Transmitted by the expert of CLEPA

Belt guide device

Special devices are sold in Europe as restraint system allegedly complying with R44/04. These systems were already discussed in the past and were banned in several countries. This report deals with a belt guide device that is sold in Russia (see GRSP-49-37) and its evaluation in a dynamic test according to R44/04.

Figure 2a: Time 0 ms – Initial P10 dummy position

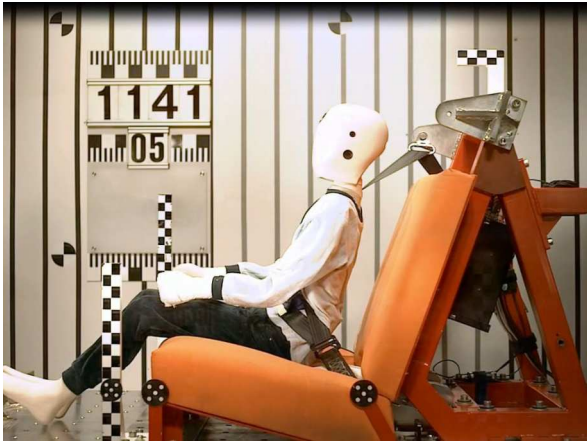
The kinematic of the occupant shows that the lap portion of the seat belt is intruding into the abdomen of the dummy, which is a clear indication of a severe submarining (Figure 2 a/b/c). This major shortcoming of such systems is that they can't maintain belt geometry for a proper restraint of the child

For group II/III the lap portion of the belt intrudes into the abdomen of the dummy, leading to a submarining situation. That means the system does not comply with §7.1.4.3.1 of R44/04.
